STATE OF OREGON  
**WATER WELL REPORT**  
 (as required by ORS 537.765)

Name City of Troutdale  
 Address 104 SE Kibling  
 City Troutdale State OR Zip 97060

# City of Troutdale - Drinker 1A Piezometer Well

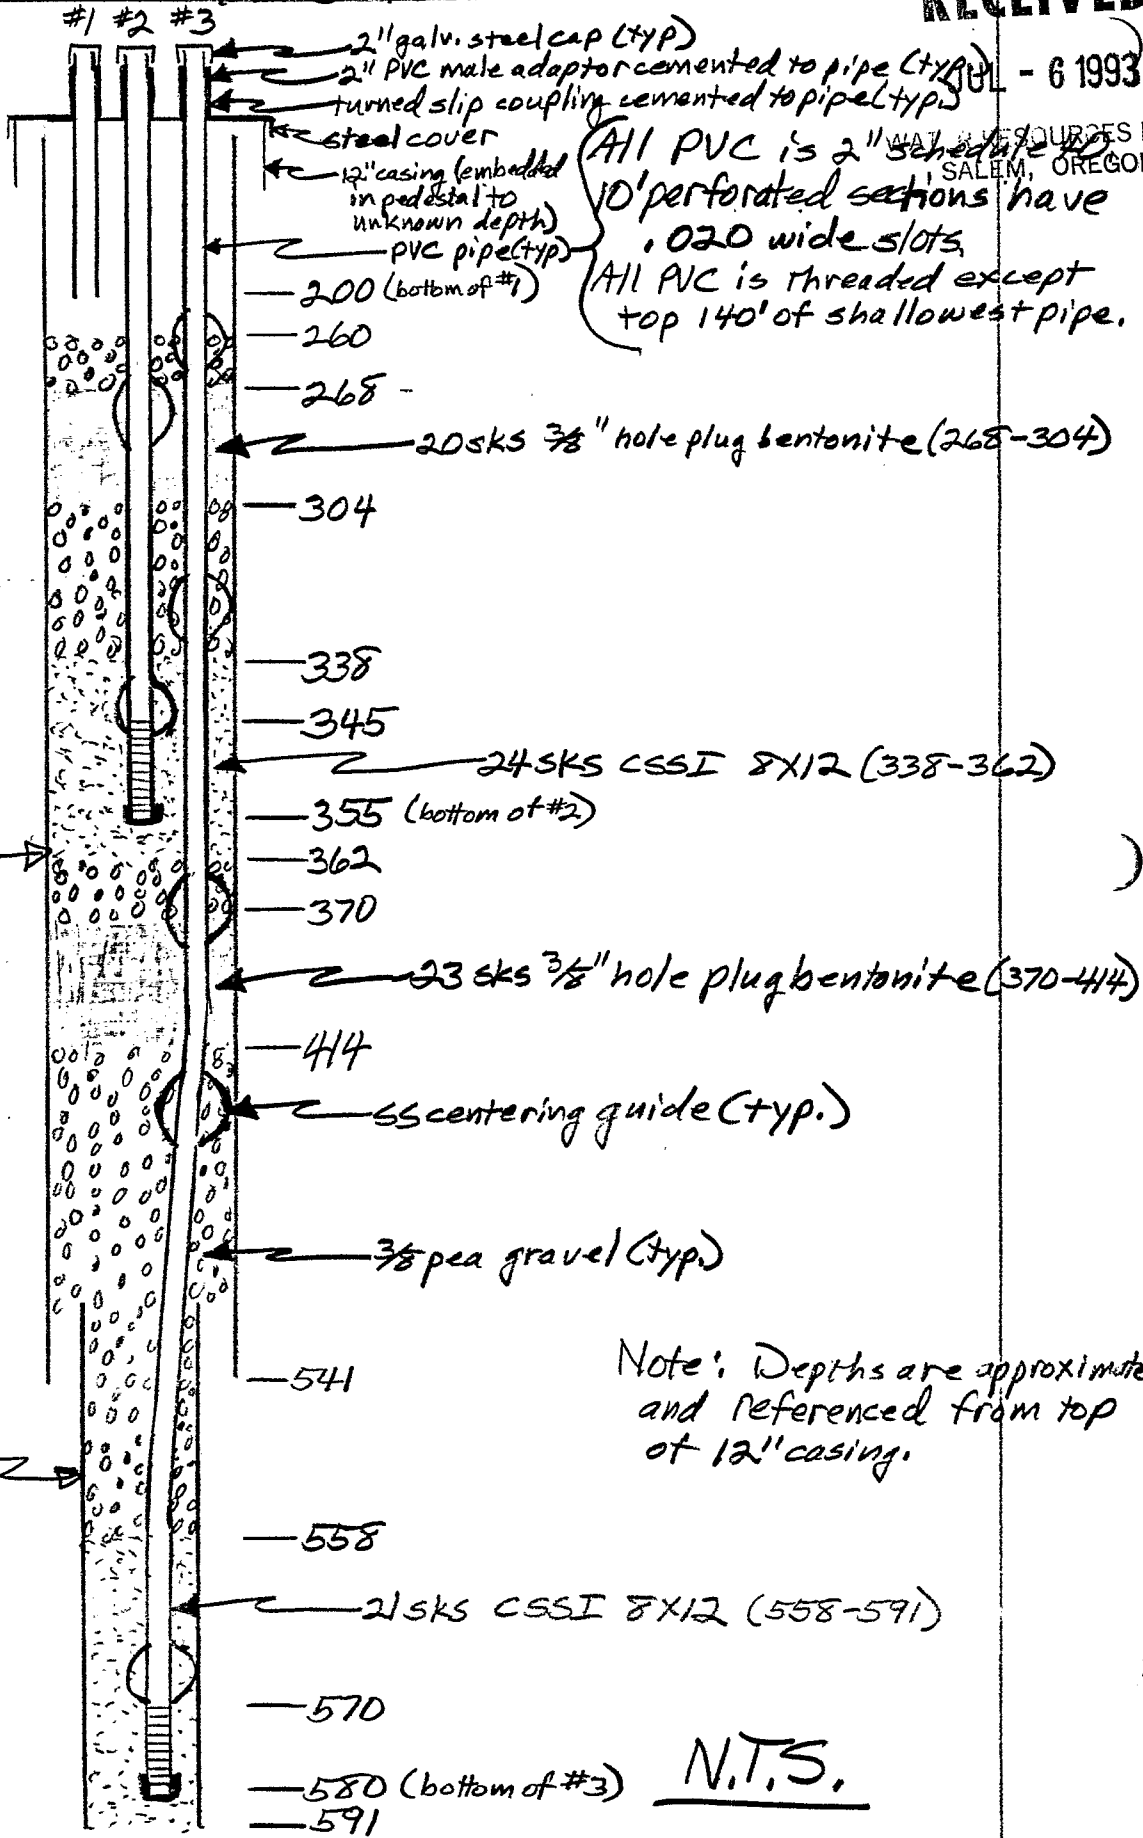
I have had an opportunity to review the information you forwarded to me concerning the City of Troutdale "Drinker" well. I apologize for the delay in responding. Robinson and Nobel intend to convert the well to a multi-completion piezometer. Due to the fact that there is no contamination verified in any of the target aquifers, I have no concern about the construction of a multi-completion piezometer. I would, however, like to see some modifications in Robinson and Noble's initial design.

The design changes are as follows:

1. I would recommend that prior to installation of the piezometer, that the current well be cleaned out of any sand and debris to the original depth of 591 feet. The sand in the bottom of the well has sufficient permeability to allow commingling of water from the bottom water producing zone upwards. This allows waste of the lower water zone. Once the sand is removed, the lower zone could be monitored, or the bottom could be abandoned with a impermeable material.
2. I would also recommend that the bentonite layers used to seal each interval off be extended to 20 feet. The 10 foot placement may not adequately seal off each interval. Also, due to the depth of placement, a greater amount of bentonite may allow for a more positive placement.
